ACCESSION NBR:8004010330 DOC.DATE: 80/03/19 NOTARIZED: YES DOCKET #
 FACIL:50-220 Nine Mile Point Nuclear Station, Unit 1, Niagara Powe 05000220
 AUTH.NAME: AUTHOR AFFILIATION
 DISE,D.P. Niagara Mohawk Power Corp.
 RECIP.NAME: RECIPIENT AFFILIATION
 EISENHUT,D.G. Division of Operating Reactors

SUBJECT: Forwards info re primary coolant pressure isolation capability as per 800223 request. Info demonstrates that continued operation of facility does not present undue safety hazard to public.

Re: Nine Mile Point Unit 1
Docket No. 50-220
DPR-63

WASH-1400, EVENT V
(LOSS OF PRESSURE ISOLATION)

SHUTDOWN COOLING SYSTEM
 FIGURE OP-4-1
 8-4-75

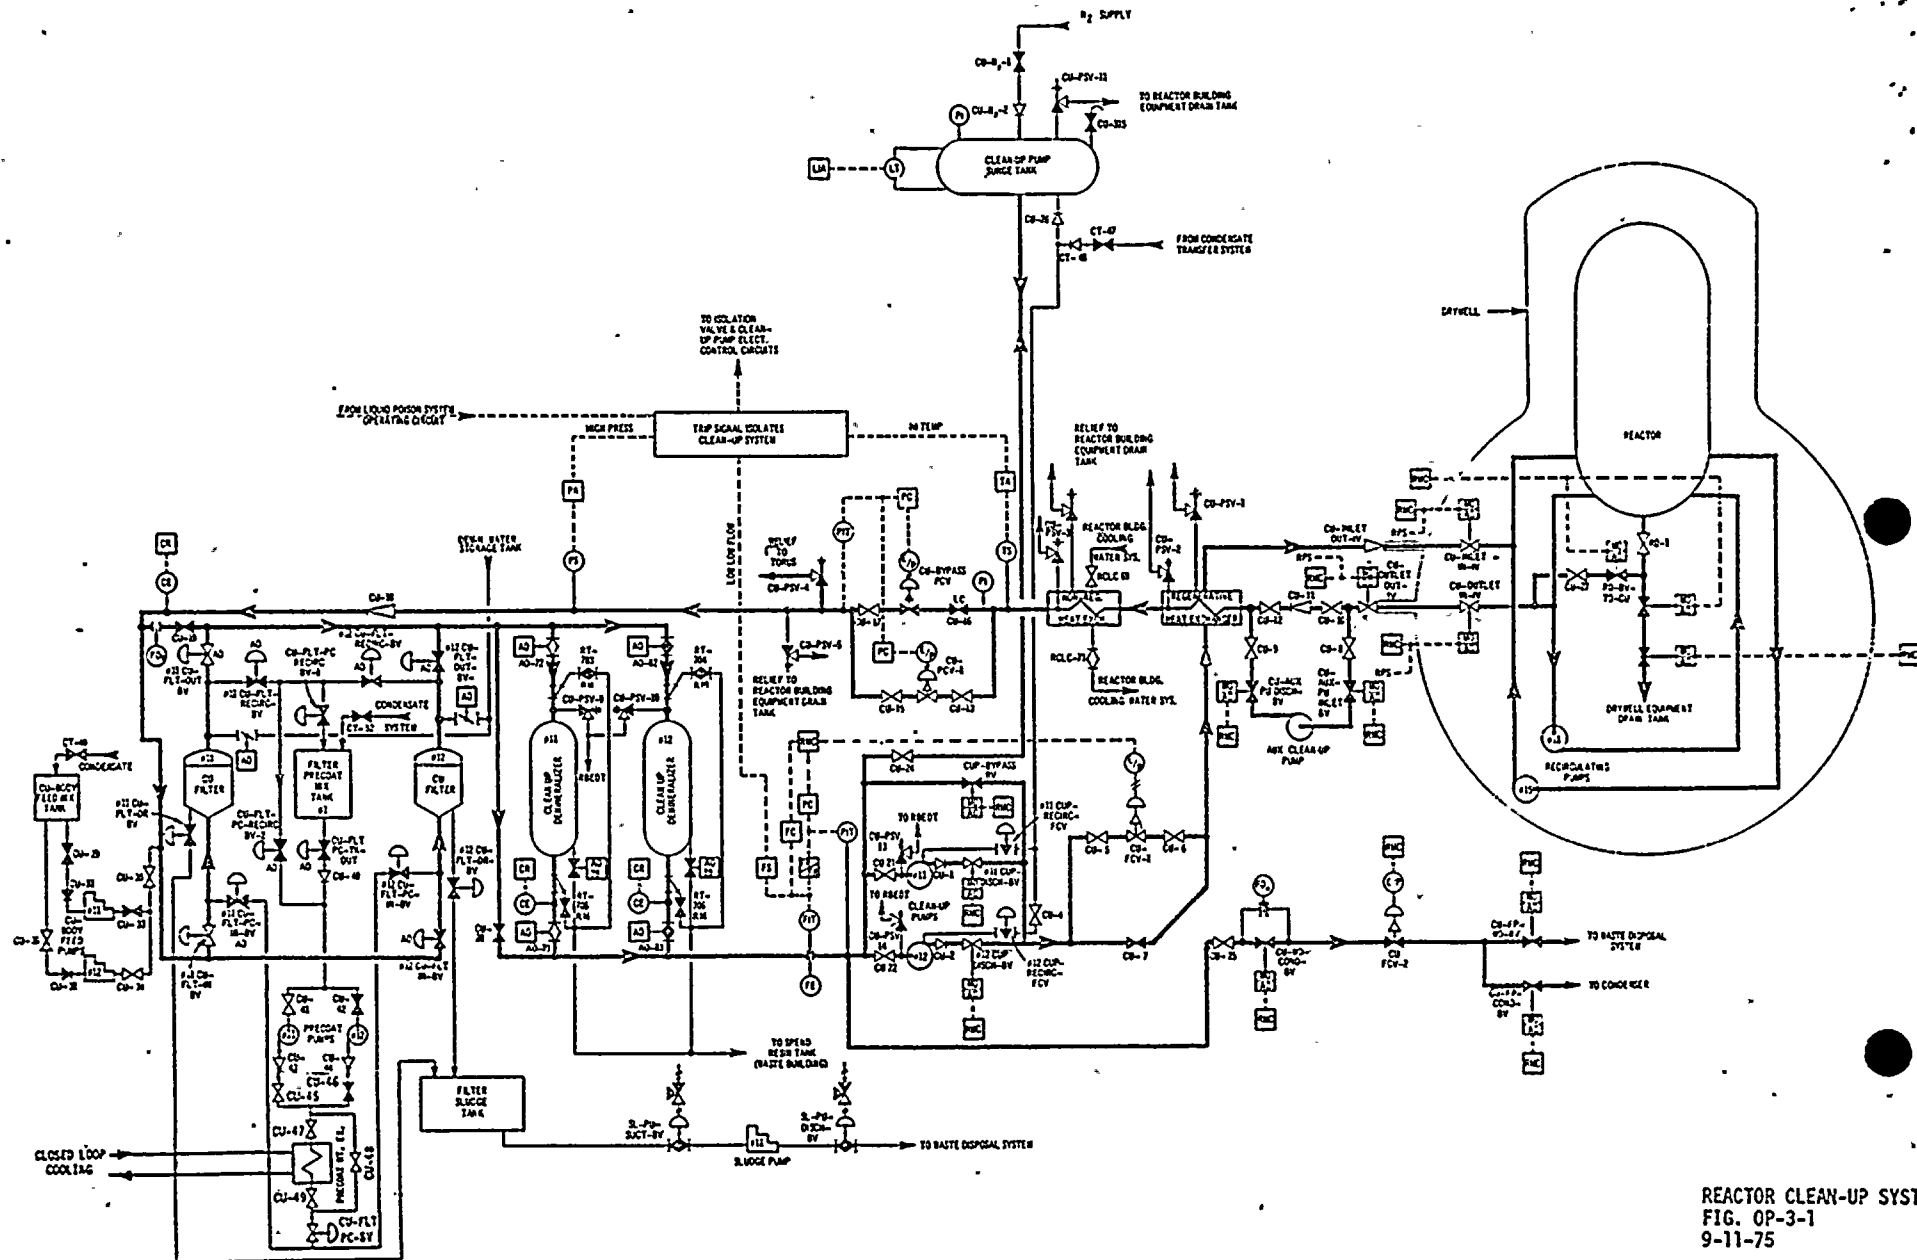
The entire shutdown cooling system is designed for reactor pressure. Therefore, there is no isolation between high and low pressure.

REACTOR CORE SPRAY SYSTEM
FIGURE OP-2-1

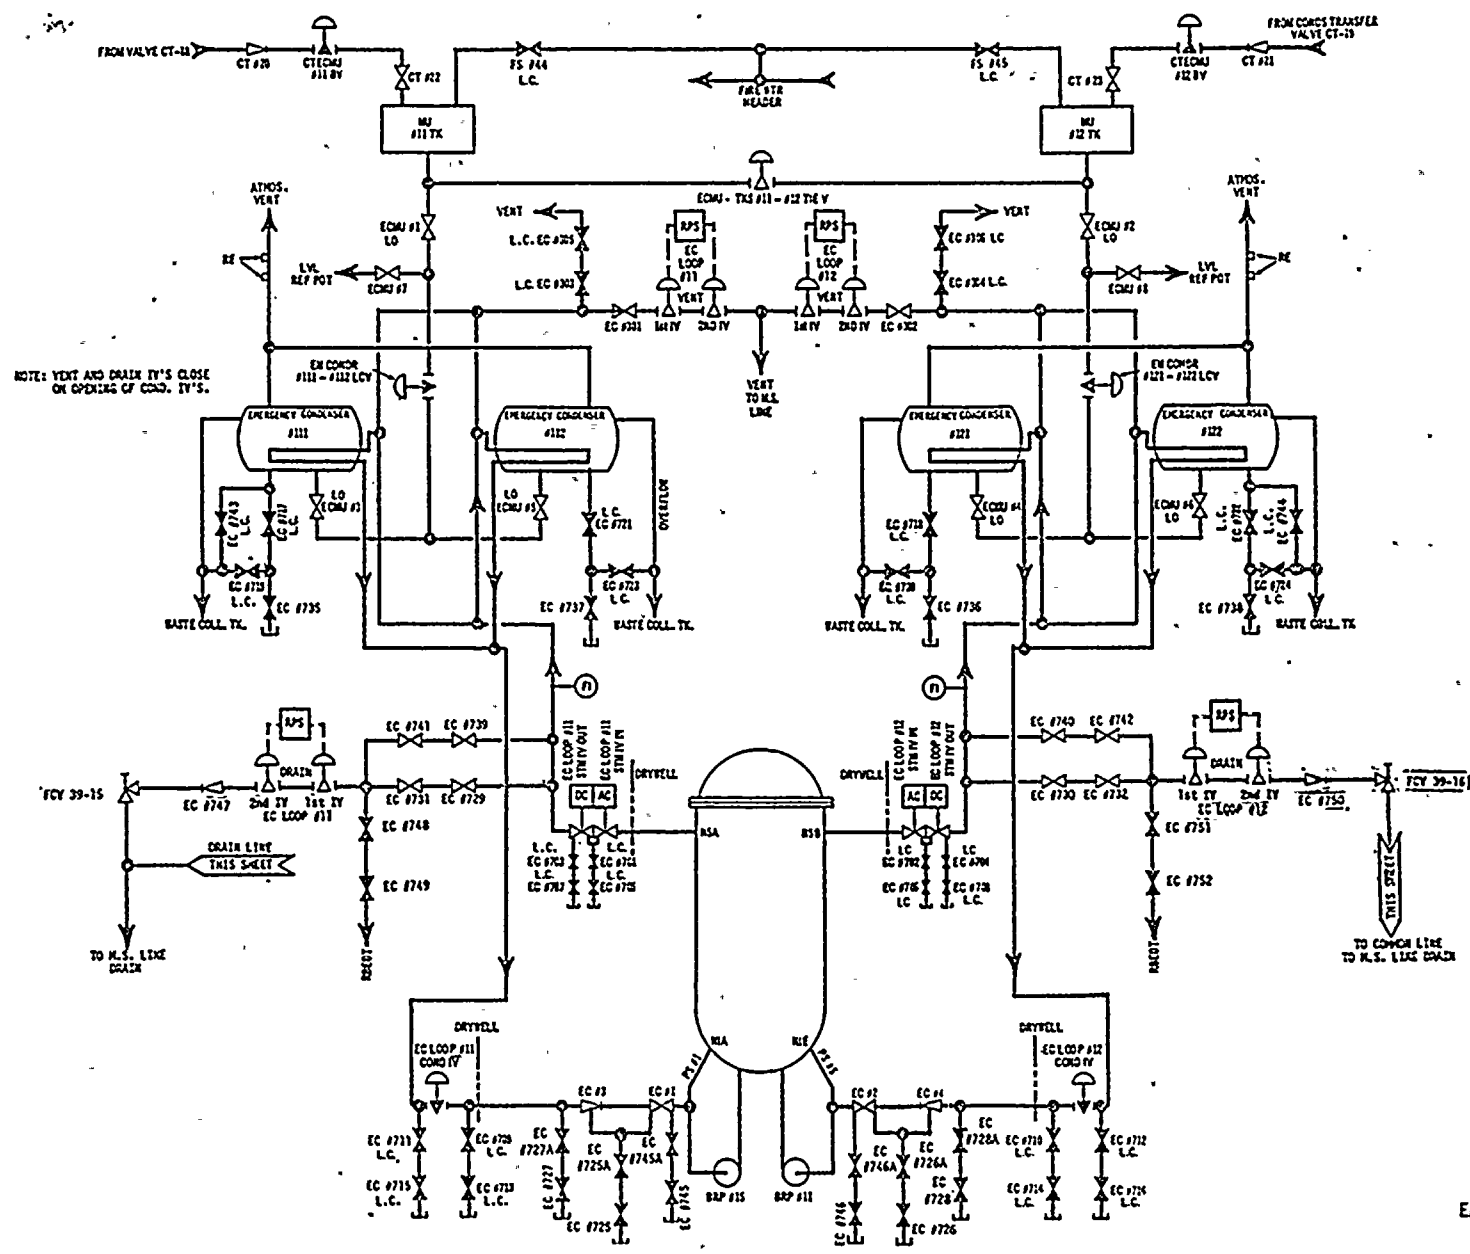
The core spray system is designed for reactor pressure from the reactor vessel to check valves CRS #19 and 20. This system does not rely on two check valves in series for pressure isolation. Normal isolation is by motor operated valve inside containment.

LIQUID POISON SYSTEM

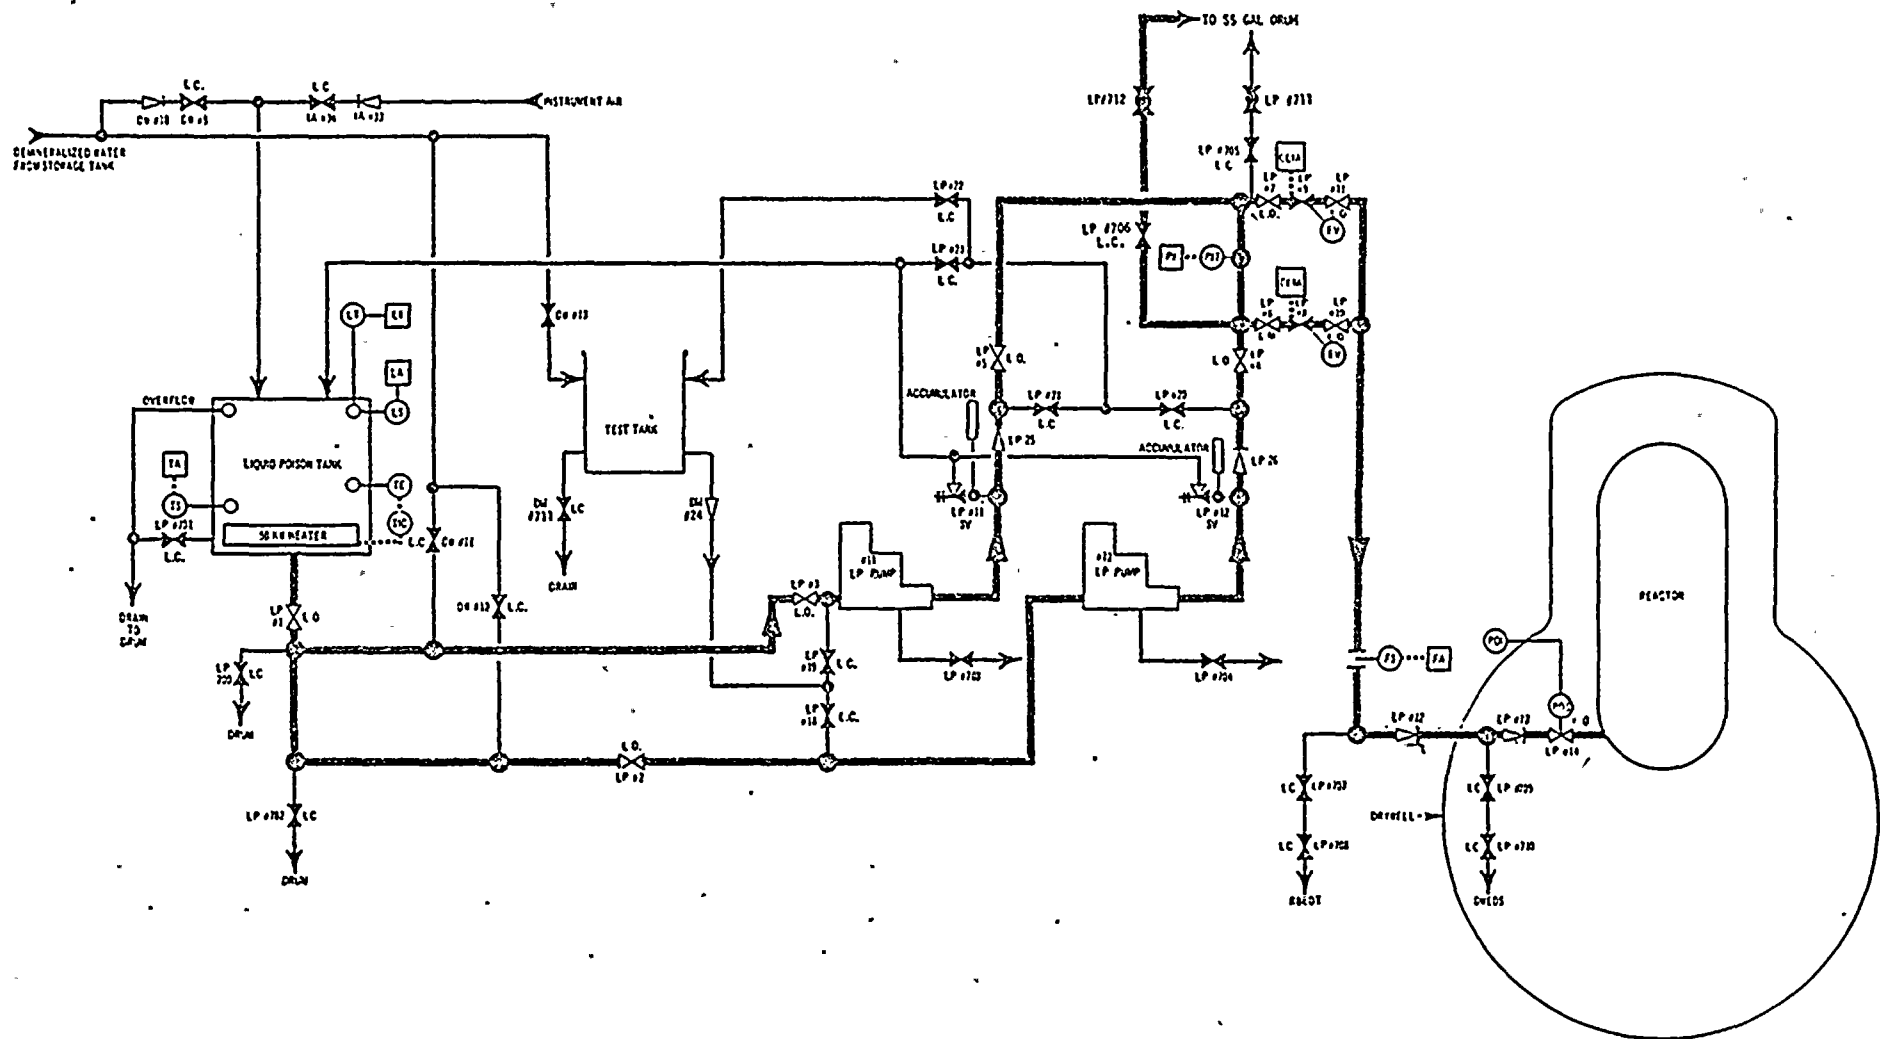
The liquid poison system is designed for reactor pressure from the reactor vessel back to and including the positive displacement pumps. This system contains two check valves in series. However, there is a normally closed explosive valve and another check between that configuration and the pumps.

HEAD SPRAY SYSTEM
FIGURE OP-4-2

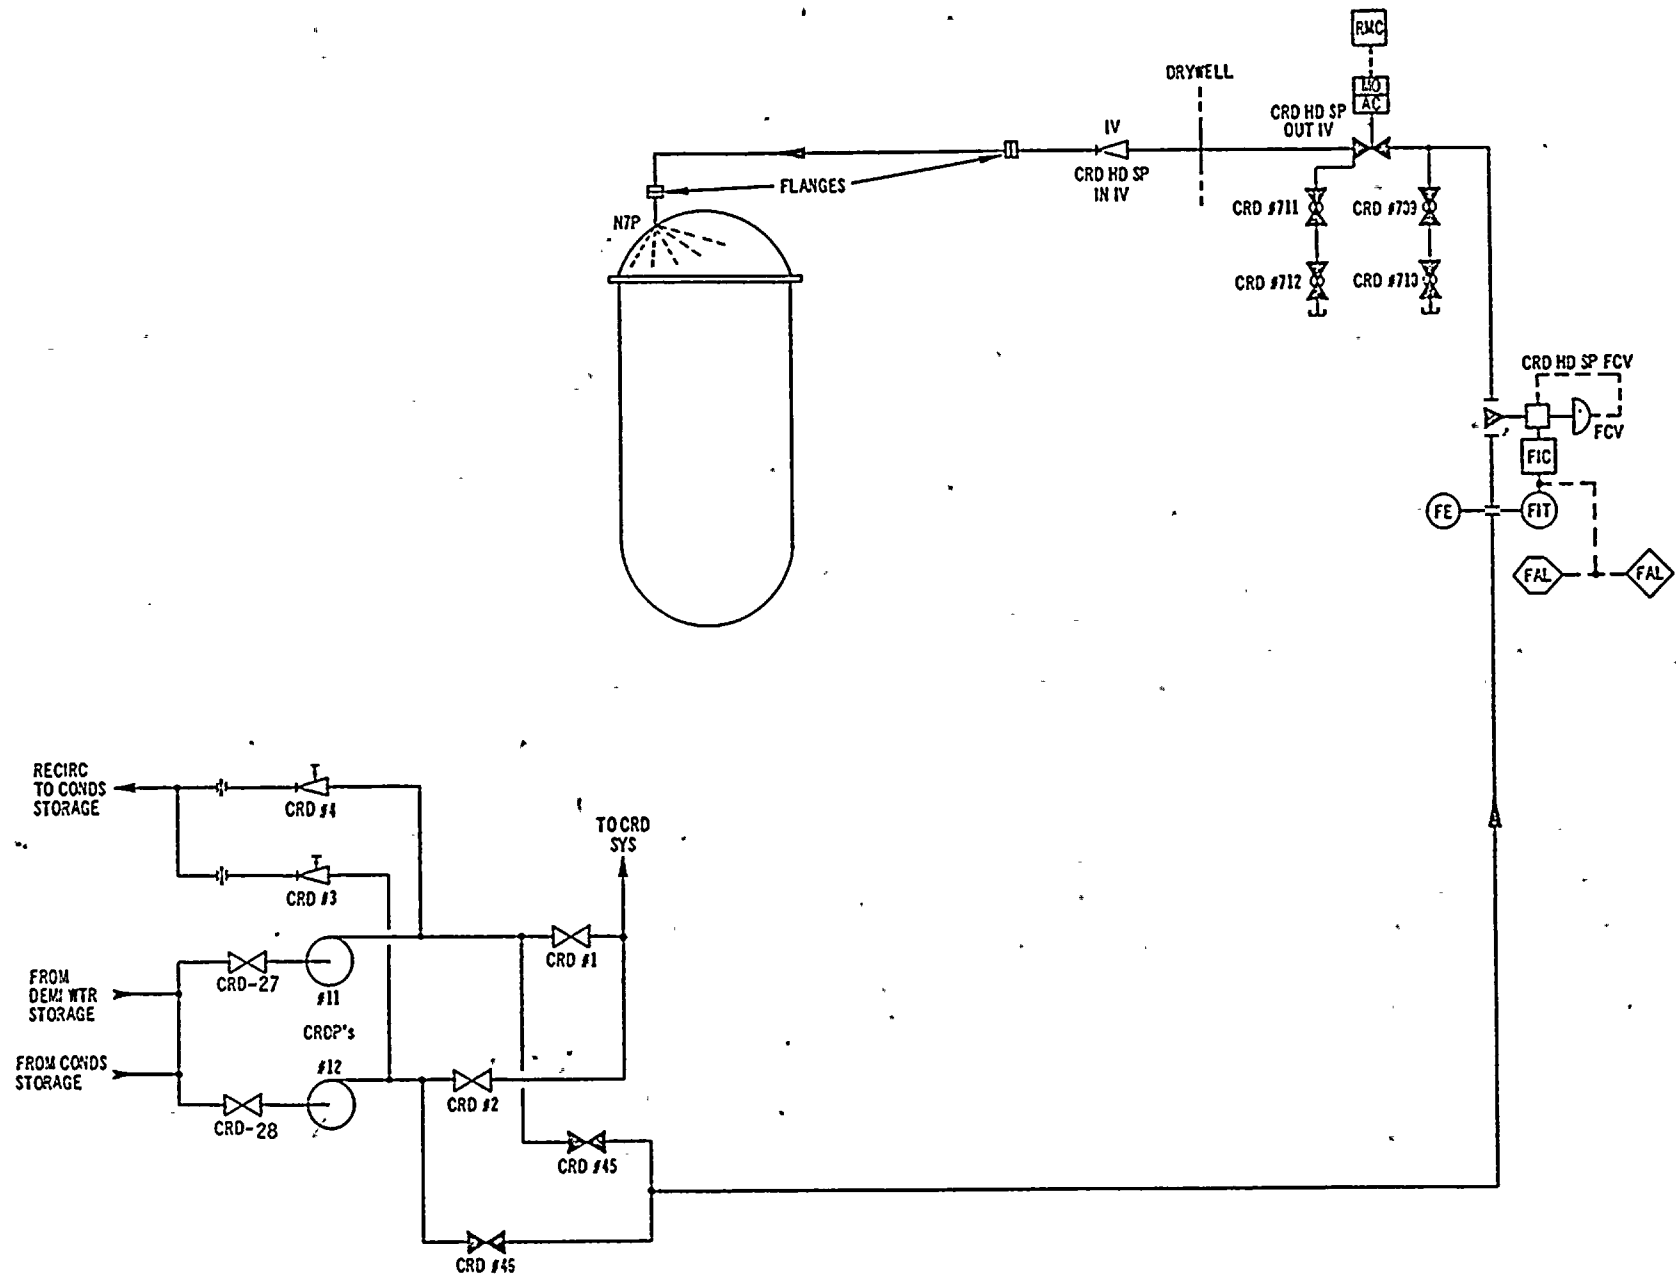
The head spray system is designed for reactor pressure from the reactor vessel back to the control rod drive pumps. This system has a check valve in series with a normally closed motor operated valve, a flow control valve and a normally closed gate valve. The system is not used during power operation.
